CONDITIONS OF APPROVAL:

Engineering - PUD Plan Checklist

Southbrooke PUD Subdivision Development Plan Initial Submittal - 04-08-2019.pdf

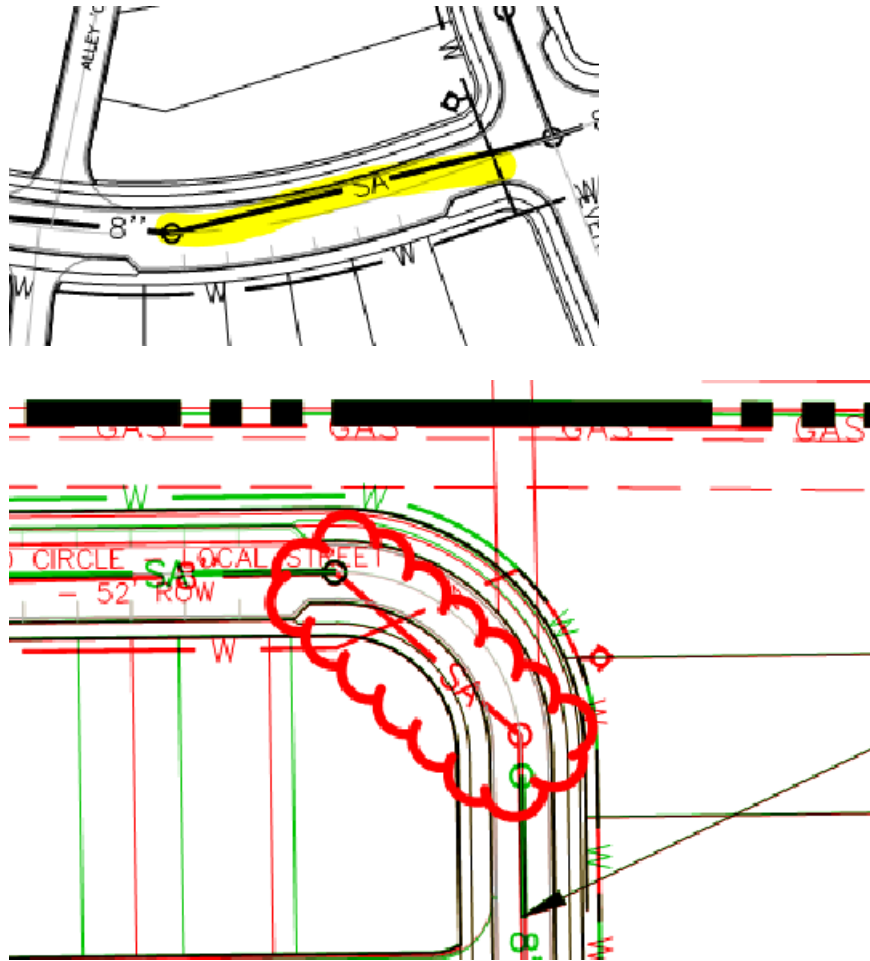
ben.mcneil@franklinton.gov The applicant shall show the proposed sanitary sewer mains in the center of the streets. There are numerous areas where the sanitary sewer main appears to be under curbs. The applicant shall revise.

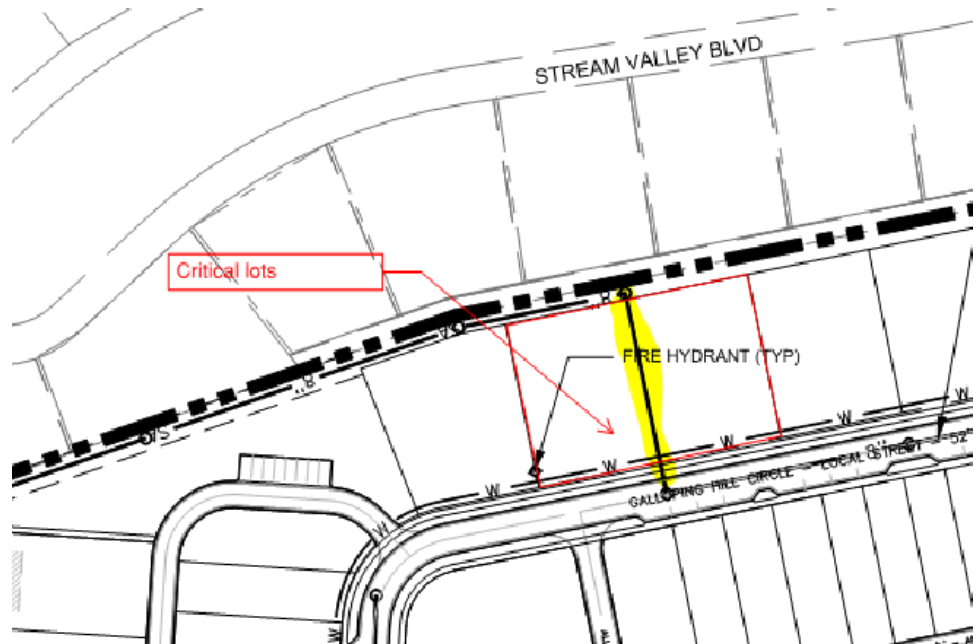
ben.mcneil@franklin.tn.gov The applicant has revised the utility plan and now shows sanitary sewer mains crossing proposed lots. The applicant shall label the lots where sanitary sewer crosses as critical lots for Water Management review.

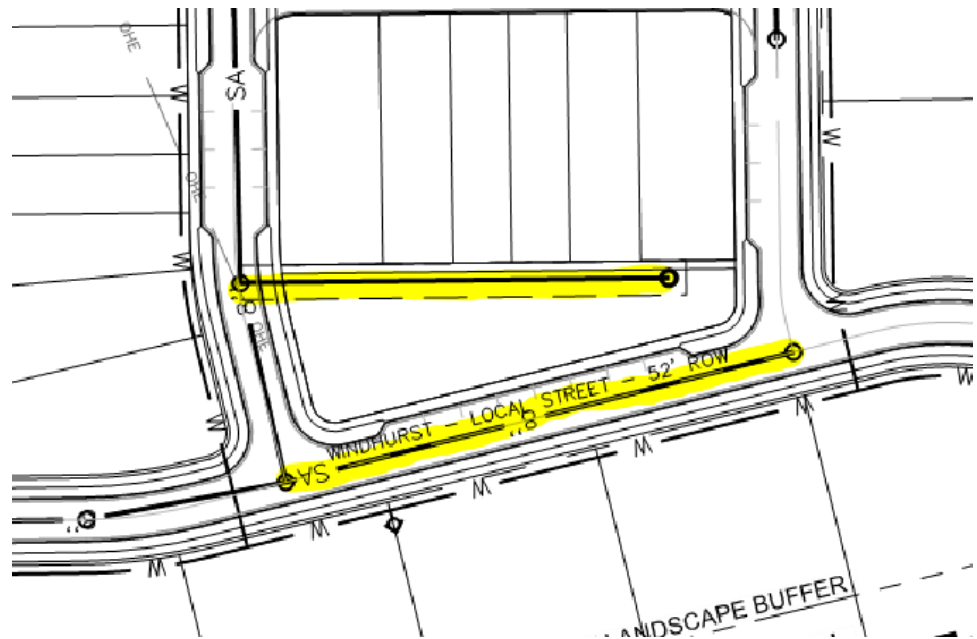
ben.mcneil@franklin.tn.gov The applicant is currently showing dual infrastructure for sanitary sewer. The applicant shall revise the layout to show single sewer mains to serve the proposed lots.
